Application LCC/2023/0030

Proposed The extraction and processing of sand and gravel including the construction of new site access roads, landscaping and screening bunds, minerals washing plant and other associated infrastructure with restoration to leisure end-uses, agricultural land and biodiversity enhancement, using imported inert fill.

Location Land off Bourbles Lane, Preesall

The principle of the developed is acceptable. However, it is recommended that planning permission is not granted as in its current form it will have an unacceptable impact on highway safety.

Figure 6.18 from MfS, reproduced below, shows typical vehicle widths.

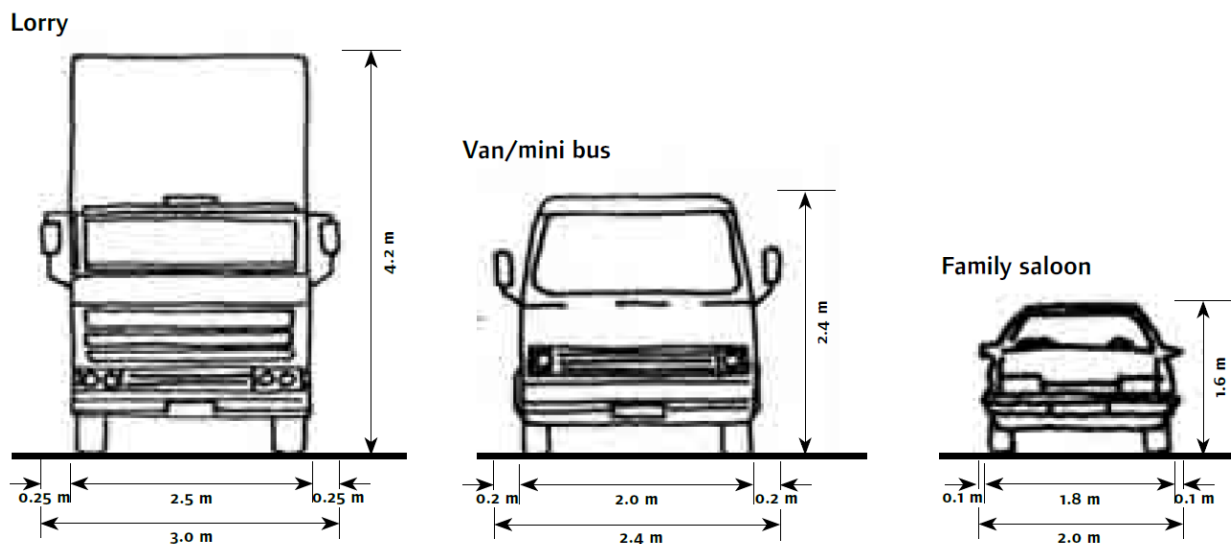
A carriageway of 5.5m can accommodate two-way HGV movements, however, this is on a straight and has minimal clearance between vehicles. Where bends exist greater widths of carriageway would be required. Further, the above does not factor in the needs of pedestrians as it assumes footways adjacent to the carriageway would be available.

Figure 7.1 from MfS, reproduced below, shows what carriageway width can typically accommodate.

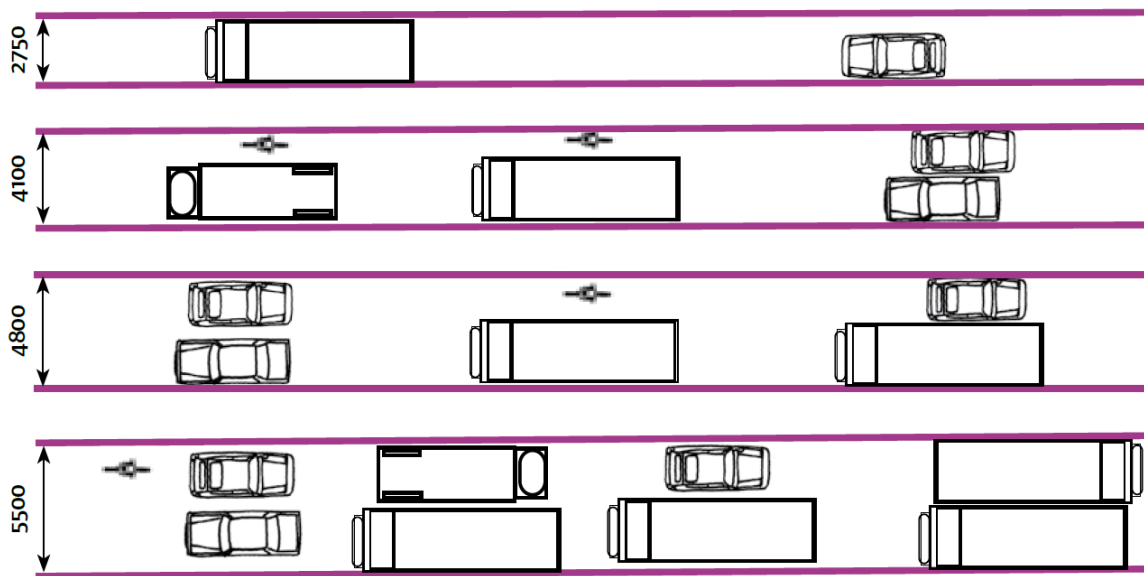
On Lancaster Road in the vicinity of the site there are no footways and very narrow verges with hedges which leads to vehicles keeping away from the edge of carriageway, thus narrowing the effective carriageway width.
